Draft Phase 3 Planning and Design Code

Stimson Consulting has been engaged by Fairland Pty Ltd to review the draft Phase 3 Planning and Design Code in relation to its potential impacts on the various land development sites it has across Metropolitan Adelaide. There are various issues affecting the different sites that I will address below.

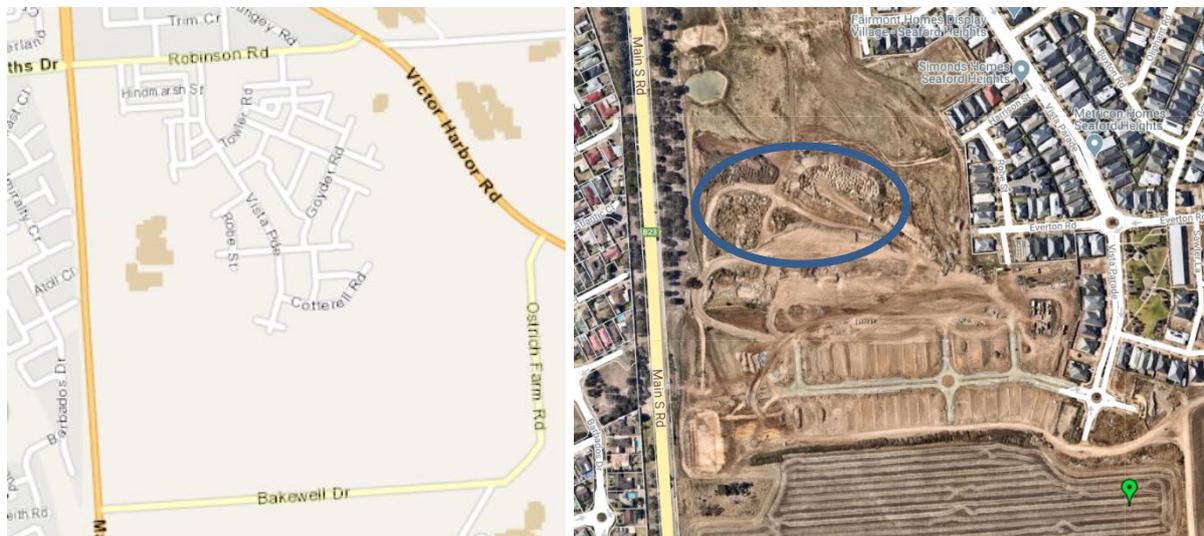
The draft PD Code has proposed a rezoning of the majority of the subject land to the Housing Diversity Neighbourhood Zone with a small portion to Suburban Activity Centre Zone. See zone map below.

A number of proposed policies in the Housing Diversity Neighbourhood Zone do not align with the type of development that the approved master plan seeks to achieve. Particularly with regard to the development of various forms of dwellings the PD Code policies will mean more applications need to go through a Performance Assessed process rather than a Deemed To Satisfy process, whereas at present many applications are able to go through the Rescode process. Such a change would mean substantial more workload for the applicants and Council for seemingly no benefit.

It is considered the subject land should be zoned Masterplanned Suburban Neighbourhood Zone. This zone has presumably been developed to guide development that have been through master plan processes.

With regard to the centre, as the catchment is below 2000 dwellings it is considered the centre should also be zoned Masterplanned Suburban Neighbourhood as opposed to the Suburban Activity Centre Zone.
